Nº 162 Service Bulletin

SUBJ: **Electronic Coin Mech Coin Return Lever Sticks.**
REDEMPTION GAMES AFFECTED:
 • **The Simpsons™ Kooky Carnival**
 • **MONOPOLY®** and • **TITANIC**

Fig. 1

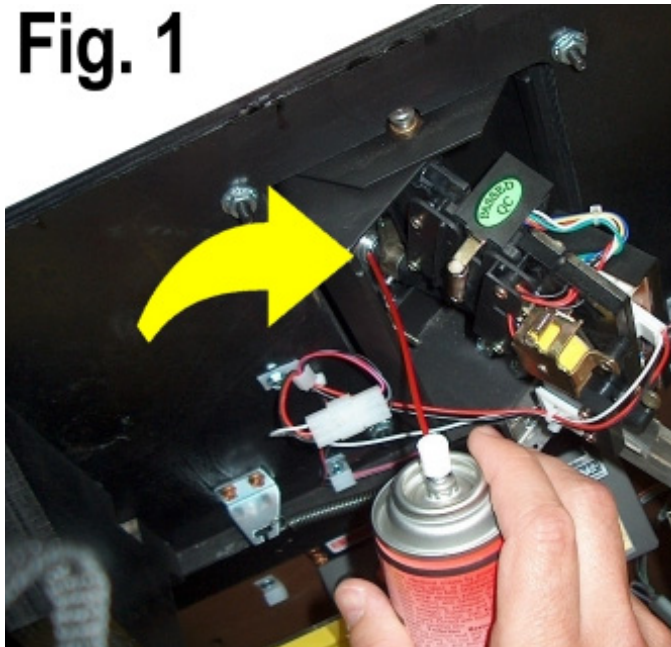
The shaft for the coin reject lever begins to stick in the down position causing the reject assembly to constantly reject coins (*see front view of the Electronic Coin Mech picture*).

Apply a **DRY TEFLON** or **SILICONE SPRAY LUBRICANT** to the shaft of the **COIN REJECT LEVER** at the points indicated in **Fig. 1 & 2**. *Note: spray both the front and back of the REJECT CAM.*
